Merged Document Report

Application No.: PL8163

Description :	
Address :	11910 LEOPARD CORPUS CHRISTI TX 78410
Record Type :

FINAL PLAT OF ALARCON ADDITION BLOCK 1, LOTS 1 AND 2

UTILITY PLAN FOR ALARCON ADDITION BLOCK 1, LOTS 1 AND 2

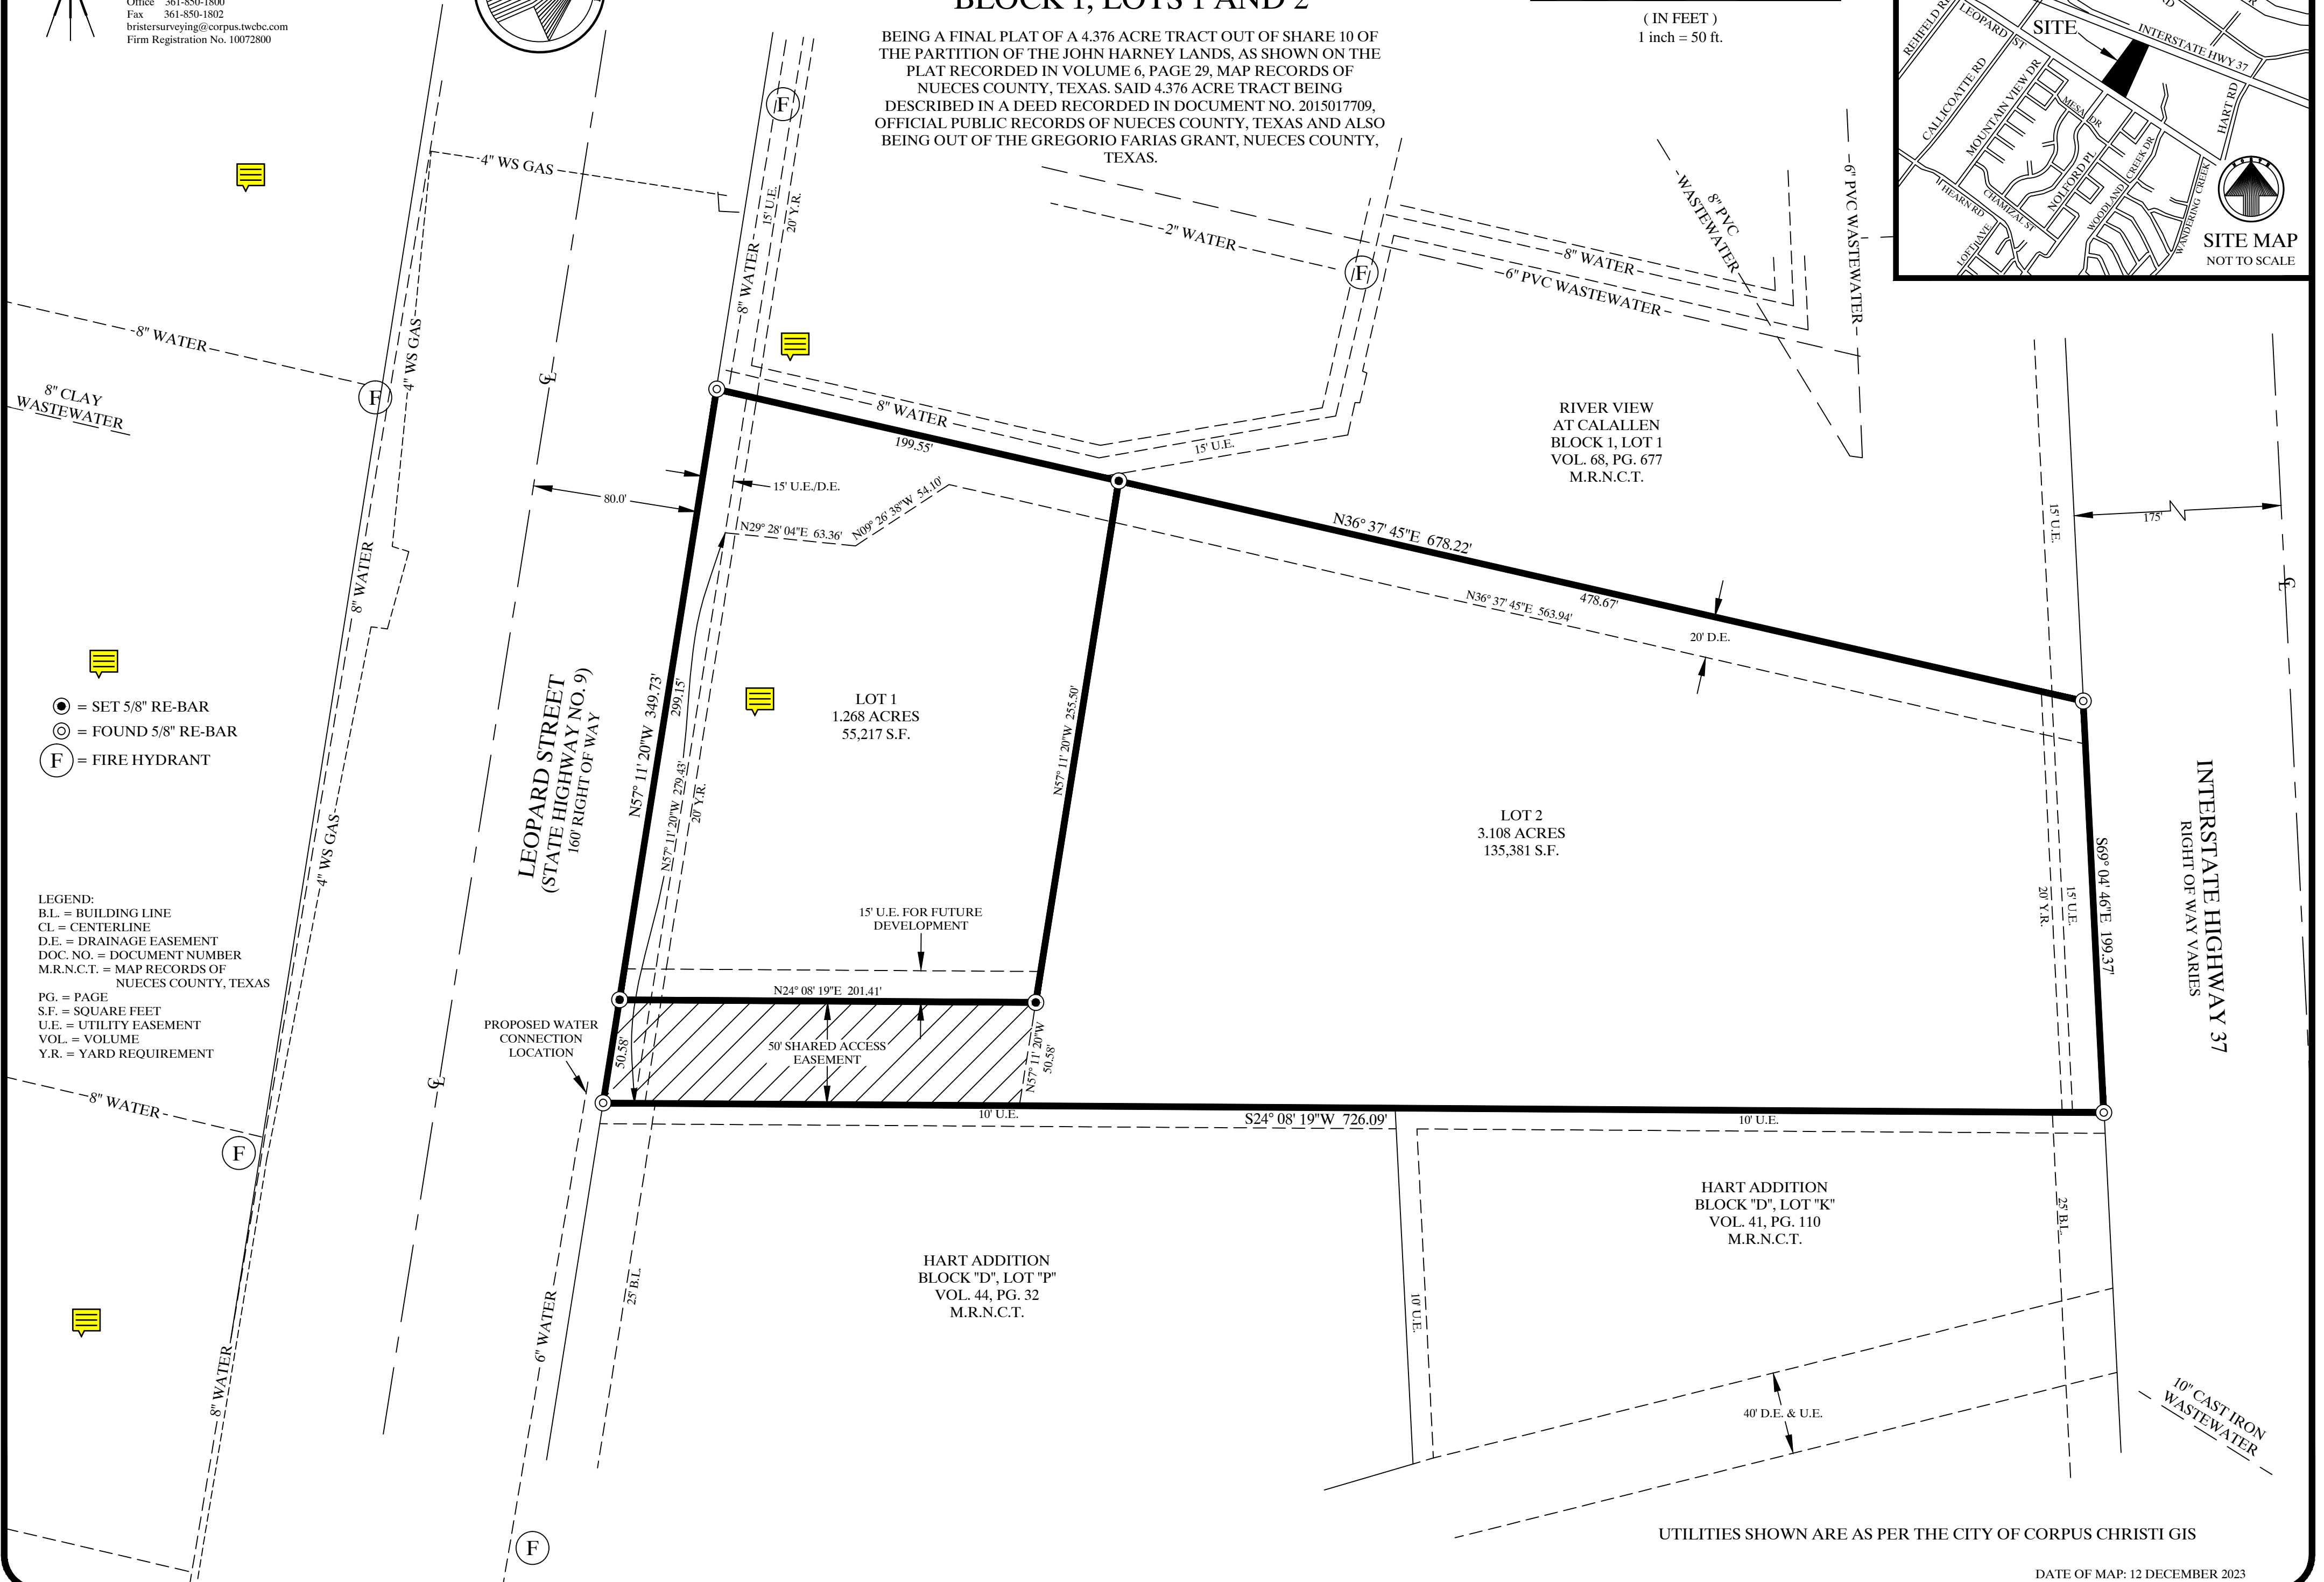
16	utility	Note	Mikail Williams : WTR	Open	Water construction is required for platting (UDC 1.2.1.D & 8.2.6; Water Distribution Standards).	
12	utility	Note	John Gonzales : WW	Open	Wastewater construction is required for platting (UDC 1.2.1.D & 8.2.7; Wastewater Collection System Standards).
